E4350B-03

S E R V I C E N O T E

E4350B Solar Array Simulator

Out of specification Peak to Peak Ripple & Noise at 20 kHz

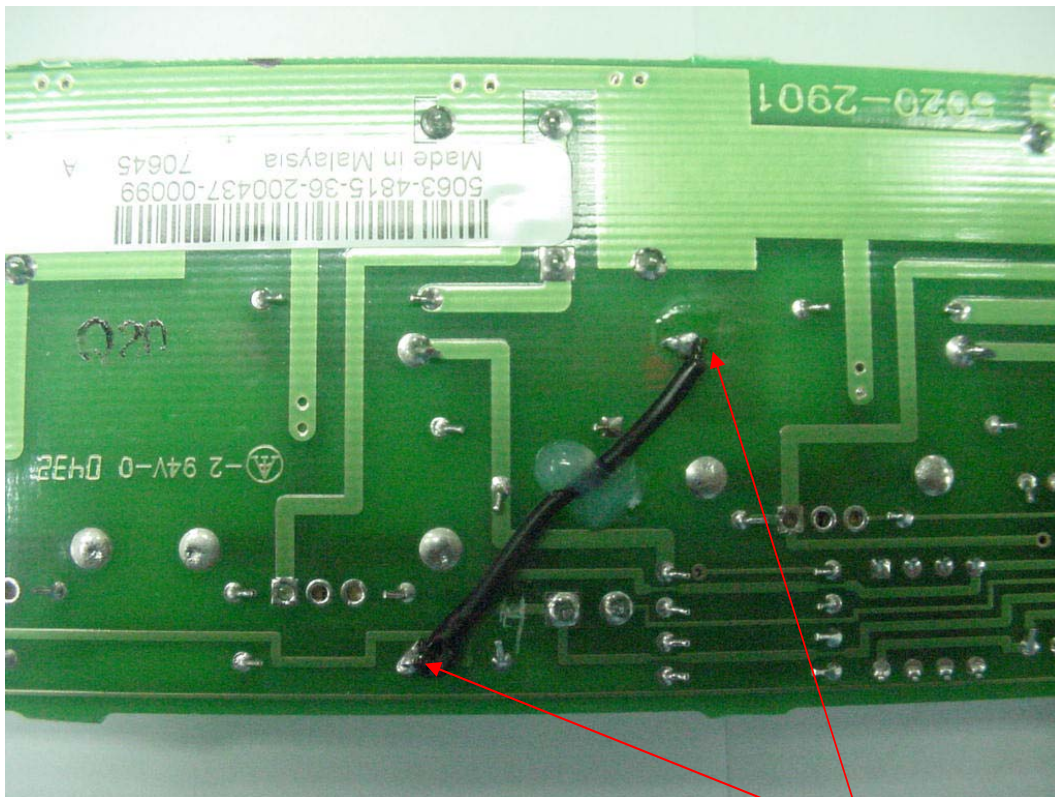
2. Cut trace between J300 and capacitor C305, on **Top and Bottom Right** side tunnel boards. **Length of trace removed should be a minimum of trace width, longer is ok.**
